#### **NOTICE OF VIOLATION**

### **INSPECTION REPORT**

Electrical Corporation:	Southern California Edison Company				
Report Number:	CAD_SCE_YLO_20250507_1307				
Inspector:	Yana Loginova				
WMP Year Inspected:	2024				
Quarterly Data Report (QDR) Referenced:	Quarter 4 (Q4)				
Inspection Selection:	Energy Safety viewed the contents of the Q4 QDR and performed an analysis that resulted in the selection of				
	the WMP initiatives and locations referenced in this report.				
Relevant WMP Initiative(s):	8.1.3.1 - Distribution Detailed Inspections and Remediations (IN-1.1)				
Date of inspection:	May 6 and 7, 2025				
City and/or County of Inspection:	Moreno Valley, Riverside County				
Inspection Purpose:	Assess the accuracy of Southern California Edison Company's QDR data, completeness of its work,				
	compliance with WMP requirements, and compliance with its protocols.

Exhibit A: Photo Log Structure ID: 4491276E

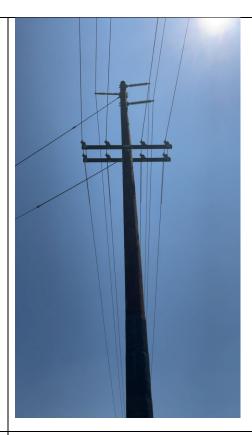
On pole ID 4491276E, Grid Hardening ID 410890030-4491276E at 34574-34810 Gilman Springs Rd, Moreno Valley, CA, 92555, USA, 33.8801406636701, -117.057241119606, the inspector observed that no wildlife covers were installed. The inspector's observation is documented in Violation 1 photographs, which are attachments to this report. Photo numbers Item1IA1Img1 andItem1IA1Img2 depict that there are no wildlife covers on the pole. Per information provided by SCE to the Compliance Inbox on June 4, 2025, at 4:13 pm, the remediation was completed.

- 1. Southern California Edison Company's 2024 WMP 8.1.3.1 Distribution Detailed Inspections and Remediations work identified that the remediation of wildlife covers was complete at this location.
- 2. The wildlife covers were not installed.

**Item1IA1Img1:** View showing no wildlife covers installed

**Item1IA1Img2:** View showing no wildlife covers installed
